ACCESSIBILITY ASSESSMENT

January 8, 2025

ADA TITLE II ASSESSMENT

Douglas Gardens Elementary School
3680 Jasper Road
Springfield, OR 97478

Photos for Barrier ID: AX528452

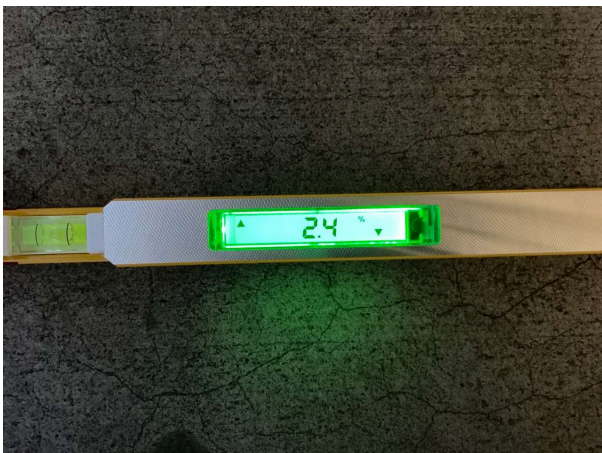
Assembly	Exterior Access Route
Type	Exterior Accessible Route
ADA Standard	403.3
Barrier Detail	The accessible route has cross slopes greater than 1:50 (2%).
Location Description	Accessible Route from Yellow Pod Classroom 15 to 16
Observed	Nov 21, 2024 by lina.sarikhani@bureauveritas.com
Site Conditions	The accessible route has cross slopes from 2.2% to 2.6%.
Length	9'
Width	8'

The walkway should be graded to a maximum 1:50 (2%) cross slope. An accessible route has maximum 1:20 (5%) running slope and maximum 1:50 (2%) cross slope. [EXCEPTION: Cross slopes not exceeding 1:48 (2.08%) are permitted.] The clear width of walking surfaces shall be 36" minimum. [EXCEPTION: The clear width shall be permitted to be reduced to 32" minimum for a length of 24" maximum provided that reduced width segments are separated by segments that are 48" long minimum and 36" wide minimum.] Where grading to maximum running slope of 1:20 (5% running slope) is not possible, provide a compliant ramped surface within the walkway with maximum slope 1:12 (8.33%) and maximum ramp run rise of 6" without handrails. If a ramped surface with running slopes greater than 1:20 (5%) and maximum 1:12 (8.33%) rises more than 6", handrails are required. The cost estimate for this barrier removal is based on grading the running slope to maximum 1:20 (5%). The quantity and order of magnitude cost estimate provided for this barrier are limited to the extent of the area identified as non-compliant. Additional costs that may be associated with removal of the barrier are not included.

Photos for Barrier ID: AX528453

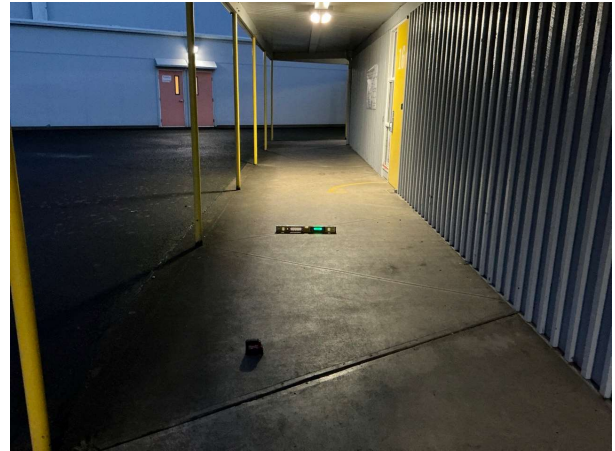
Assembly	Exterior Access Route
Type	Exterior Accessible Route
ADA Standard	403.3
Barrier Detail	The accessible route has cross slopes greater than 1:50 (2%).
Location Description	Accessible Route from Yellow Pod Classroom 15 to 16
Observed	Nov 21, 2024 by lina.sarikhani@bureauveritas.com
Site Conditions	The accessible route has cross slopes from 2.2% to 2.9%.
Highest Cross Slope	2.9%
Lowest Cross Slope	2.2%
Length	9'
Width	8'

The walkway should be graded to a maximum 1:50 (2%) cross slope. An accessible route has maximum 1:20 (5%) running slope and maximum 1:50 (2%) cross slope. [EXCEPTION: Cross slopes not exceeding 1:48 (2.08%) are permitted.] The clear width of walking surfaces shall be 36" minimum. [EXCEPTION: The clear width shall be permitted to be reduced to 32" minimum for a length of 24" maximum provided that reduced width segments are separated by segments that are 48" long minimum and 36" wide minimum.] Where grading to maximum running slope of 1:20 (5% running slope) is not possible, provide a compliant ramped surface within the walkway with maximum slope 1:12 (8.33%) and maximum ramp run rise of 6" without handrails. If a ramped surface with running slopes greater than 1:20 (5%) and maximum 1:12 (8.33%) rises more than 6", handrails are required. The cost estimate for this barrier removal is based on grading the running slope to maximum 1:20 (5%). The quantity and order of magnitude cost estimate provided for this barrier are limited to the extent of the area identified as non-compliant. Additional costs that may be associated with removal of the barrier are not included.

Photos for Barrier ID: AX528456

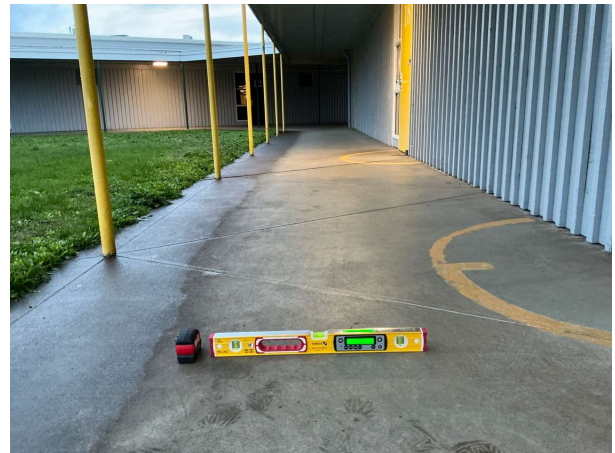
Assembly	Exterior Access Route
Type	Exterior Accessible Route
ADA Standard	403.3
Barrier Detail	The accessible route has cross slopes greater than 1:50 (2%).
Location Description	Accessible Route from Yellow Pod Classroom 17 to 18
Observed	Nov 21, 2024 by lina.sarikhani@bureauveritas.com
Site Conditions	The accessible route has a cross slope of 2.3%.
Highest Cross Slope	2.3%
Length	10'
Width	8'

The walkway should be graded to a maximum 1:50 (2%) cross slope. An accessible route has maximum 1:20 (5%) running slope and maximum 1:50 (2%) cross slope. [EXCEPTION: Cross slopes not exceeding 1:48 (2.08%) are permitted.] The clear width of walking surfaces shall be 36" minimum. [EXCEPTION: The clear width shall be permitted to be reduced to 32" minimum for a length of 24" maximum provided that reduced width segments are separated by segments that are 48" long minimum and 36" wide minimum.] Where grading to maximum running slope of 1:20 (5% running slope) is not possible, provide a compliant ramped surface within the walkway with maximum slope 1:12 (8.33%) and maximum ramp run rise of 6" without handrails. If a ramped surface with running slopes greater than 1:20 (5%) and maximum 1:12 (8.33%) rises more than 6", handrails are required. The cost estimate for this barrier removal is based on grading the running slope to maximum 1:20 (5%). The quantity and order of magnitude cost estimate provided for this barrier are limited to the extent of the area identified as non-compliant. Additional costs that may be associated with removal of the barrier are not included.

Photos for Barrier ID: AX528446

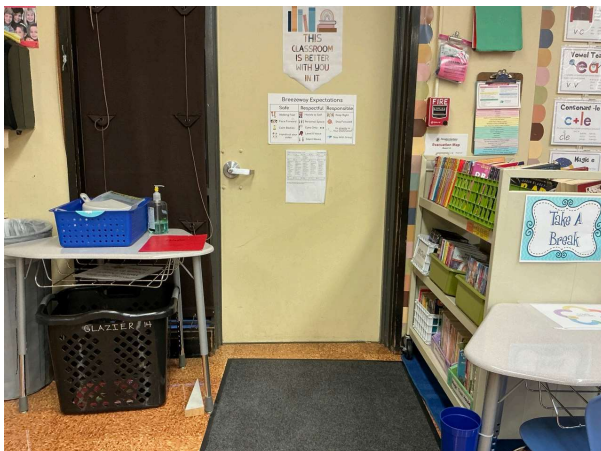
Assembly	Exterior Access Route	
Type	Door	
ADA Standard	404.2.4; Table 404.2.4.1	
Barrier Detail		
The push side of the accessible door does not have the required maneuvering clearances.		
Location Description	Classroom Doors Sample	
Observed	Nov 21, 2024 by lina.sarikhani@bureauveritas.com	
Site Conditions		
For a front approach on the push side, the side clearance is less than 12 inches due to the location of furniture.		
Resolution		
Redesign to provide the required maneuvering clearance on the push side the door. The required depth of the maneuvering clearance is 48" minimum. The required side clearance is 12" minimum on the latch side of the door. Maneuvering clearance shall extend the full width of the doorway and the required latch side clearance. Floor or ground space within the required maneuvering clearance shall be maximum 1:48 (2.08%) slope. Changes in level are not permitted.		
Quantity	Unit Cost	Total Cost

Photos for Barrier ID: AX528451

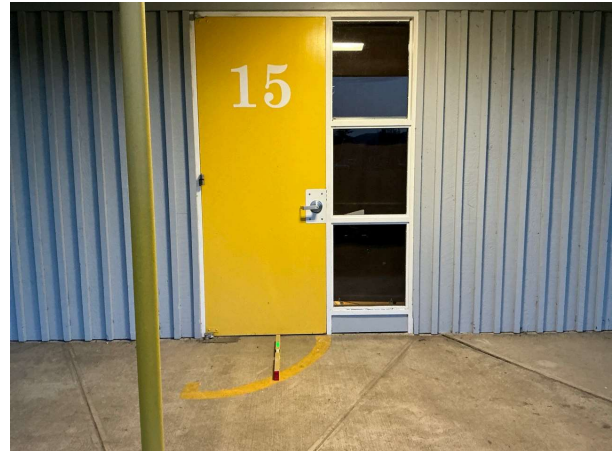
Assembly	Exterior Access Route
Type	Exterior Accessible Route
ADA Standard	R204, R302.7.3
Barrier Detail	PROWAG - The opening in the drain or grate is more than 1/2".
Location Description	Accessible Route from Library to Cafeteria
Observed	Nov 21, 2024 by lina.sarikhani@bureauveritas.com
Site Conditions	The accessible route has openings greater than 1/2 inch wide.

Remove and replace with an ADA compliant grate that has openings no greater than 1/2" wide in one direction, and elongated openings shall be placed so that the long dimension is perpendicular to the dominant direction of travel. Openings in floor or ground surfaces shall not allow passage of a sphere more than 1/2" (13 mm) diameter'. Elongated openings shall be placed so that the long dimension is perpendicular to the dominant direction of travel.
